### UNITED STATES PATENT AND TRADEMARK OFFICE

APPLICATION NO.	FILING DATE	FIRST NAMED INVENTOR	ATTORNEY DOCKET NO.	CONFIRMATION NO.	
09/684,658	10/10/2000	Hugh G. Loebner		4106	
75	590 04/25/2002				
HUGH LOEBNER			EXAMINER		
c/o CROWN INDUSTRIES INC 155 NORTH PARK St			GARCIA, E	GARCIA, ERNESTO	
EAST ORANG	E, NJ 0/01/		Hugh G. Loebner  CARCIA, E  ART UNIT  3679	PAPER NUMBER	
		3679			
			DATE MAILED: 04/25/2002

#### **DETAILED ACTION**

FIG. 4

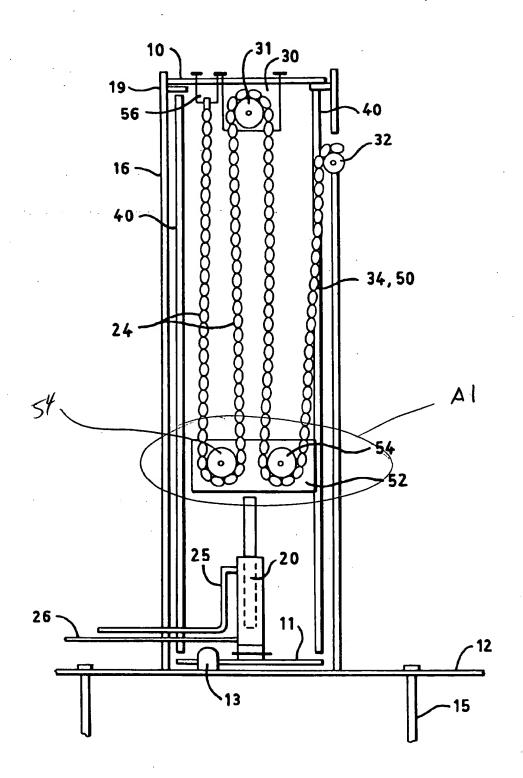
Gompertz et al. (See attachment) teaches in Figure 4 a bottom block assembly

A1 comprising rollers 54 to quadruple a length of tape 34, 50 per distance that is
released (col. 5, line 64 - col. 6, line 5) from the post. Therefore, as taught by Gompertz
et al., it would have been obvious to one of ordinary skill in the art at the time the
invention was made to comprise the bottom block assembly of more than one roller to
quadruple the length a tape that is released from a post.
